**CITY OF RICHLAND DEVELOPMENT SERVICES DIVISION  
STAFF REPORT TO THE HEARING EXAMINER**

PROPOSAL NAME: Sienna Hills - Preliminary Plat

FILE NO.: S2019-101

DESCRIPTION: Request to divide 99.15 acres into 285 single family residential lots and twelve (12) Tracts.

**Figure 1: Badger Mountain Subarea Plan “Developed and Undeveloped Parcels”**

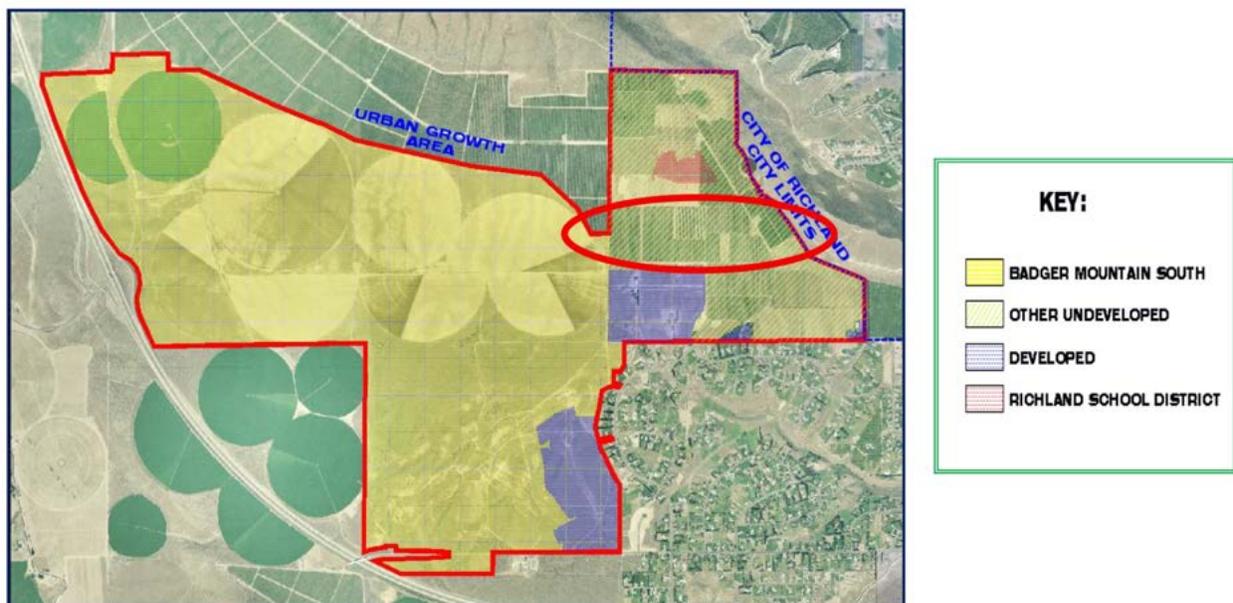
The Subarea Plan was adopted in April 2010 as an appendix to the Comp Plan to support the December 2010 annexation of the area and clearly defines Badger Mountain South as separate from the other undeveloped lands in the subarea (*Figure 1*).

*Figure 3 of the Subarea Plan (page 9). Subject site, indicated by red oval, located in Other Undeveloped, not Badger Mountain South.*

**Figure 2: Comprehensive Plan Future Land Use Map**

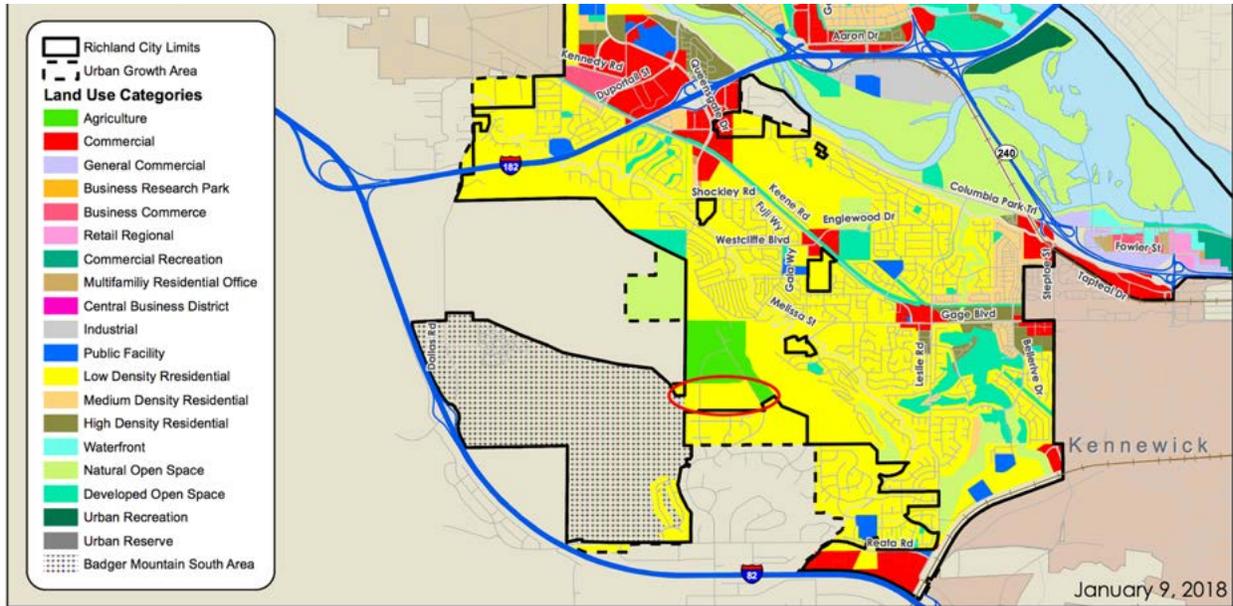
Subject site, indicated by red oval, is designated for Low Density Residential and Agriculture, not Badger Mountain South Area.

The proposed rezone is inconsistent with the Comp Plan FLUM designations of Low Density Residential and Agriculture (*Figure 2*). Per Table LU-1 in the Comp Plan (page 18), the implementing zoning categories of the Low Density Residential designation include R-1-12, R-1-10, and SAG. The implementing zoning categories of Agriculture are AG and FP.

**Figure 3: Zoning Map**

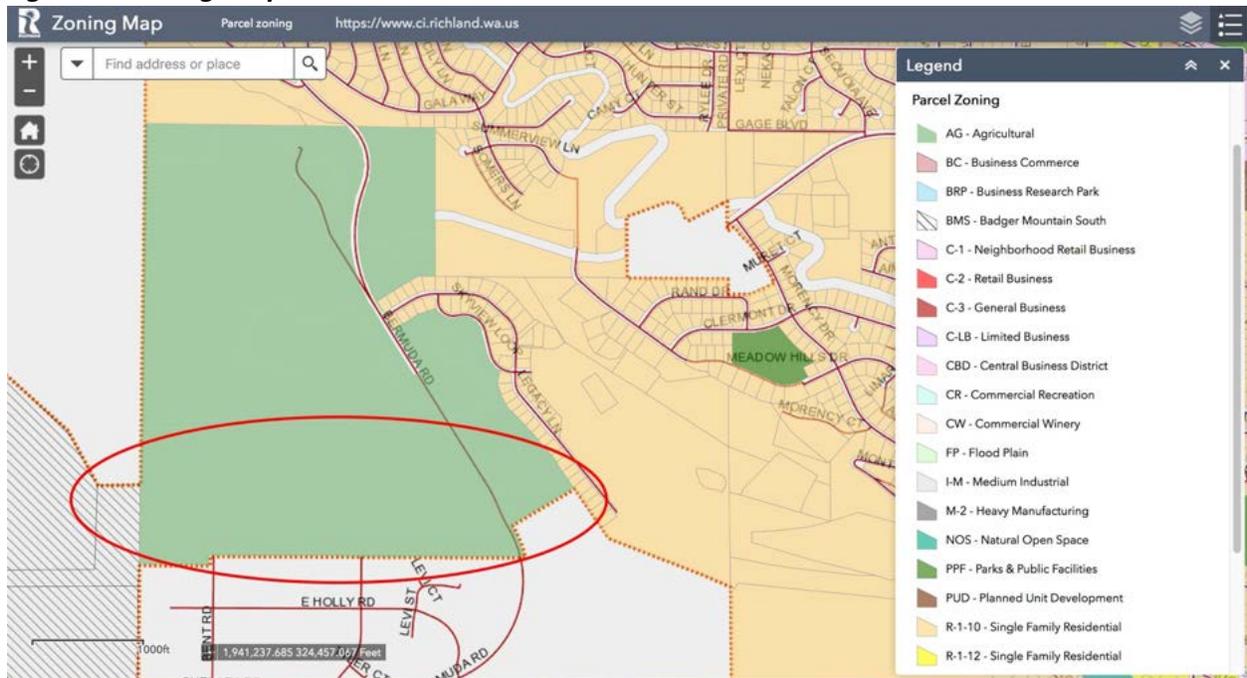
The current [Zoning Map](#) (*Figure 3*) provides further evidence that the subject site was not intended to be guided by the Subarea Plan because it is not included in the Badger Mountain South zoning category and instead is designated as AG – Agricultural, consistent with the FLUM.

From Richland GIS map. Subject site, indicated by red oval, located in AG – Agricultural, not Badger Mountain South.

The applicant proposes to rezone the Subject Site from AG - Agriculture (*Figure 3*) to R-1-10 – Single Family Residential, R-2 – Medium Density Residential, and C-LB - Limited Business zoning (*Figure 4*). This proposal is somewhat consistent with the Subarea Plan Land Use Plan (*Figure 5*), which shows a mix of Commercial, Medium Density Residential (5.1-10 DU/AC), Low Density Residential (0-5 DU/AC), and Civic (Parks, Trails, Open Space), but strays from the Land Use Plan in important ways.

**Figure 5: Badger Mountain Subarea Land Use Plan**

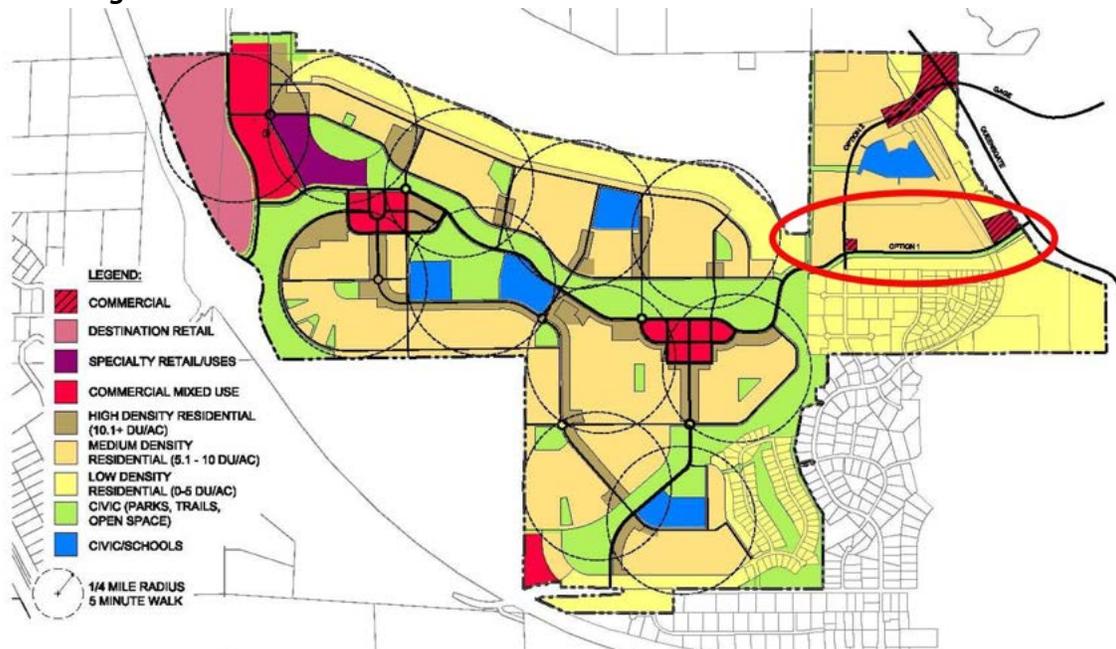
The proposed development is inconsistent with the Subarea Land Use Plan (*Figure 5*) in three major ways:

Should the Subarea Land Use Plan (*Figure 5*) be utilized to determine the Future Land Use designation, the proposed development should be conditioned to be consistent with that plan by:

**Figure 6: Excerpt from 2020-2025 Six Year Transportation Improvement Program Map**

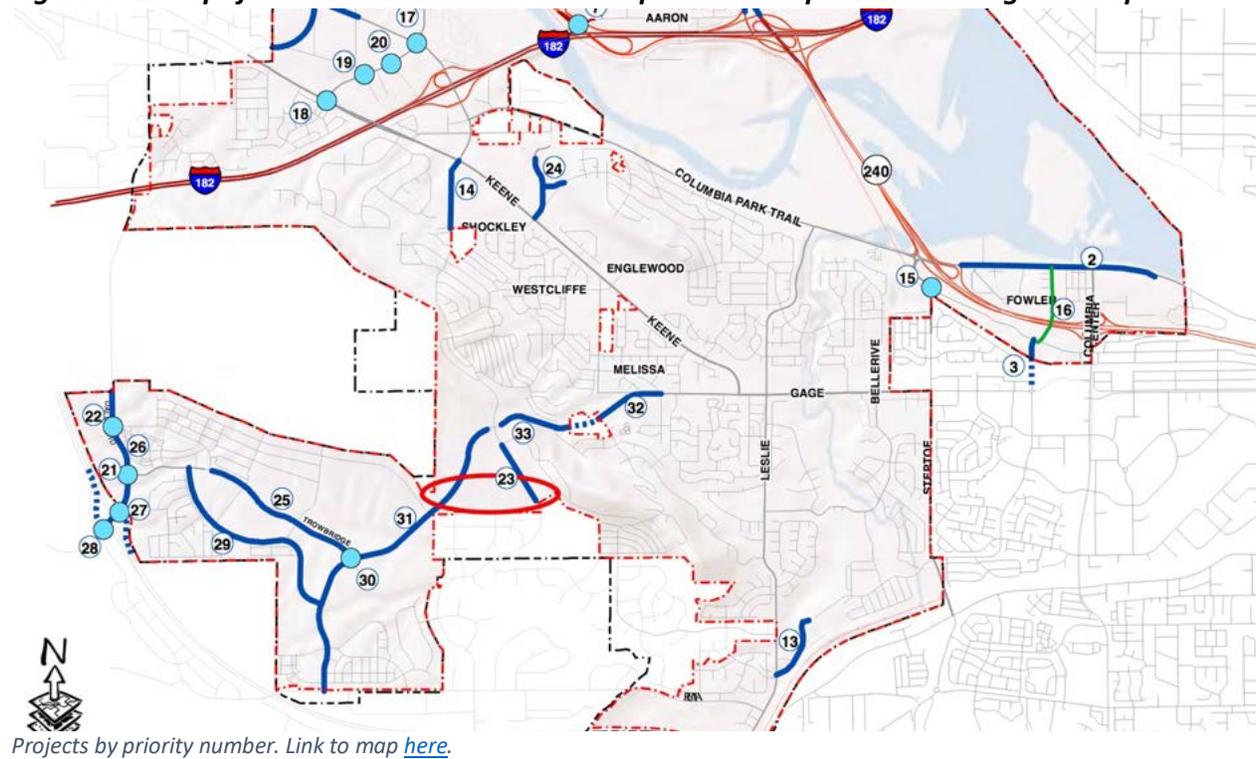
- The proposed development precedes several priority transportation network projects identified to support development in the area (*Figure 6*). Transportation improvement Projects 31, 32, and 33 improve and extend Gage to provide a more direct route to commercial centers, reducing vehicle miles traveled and limiting impact to single family residential areas.

- Without adequate and efficient transportation networks in place, additional traffic on long routes through single family residential neighborhoods will negatively impact livability of those neighborhoods. A brief traffic analysis follows.
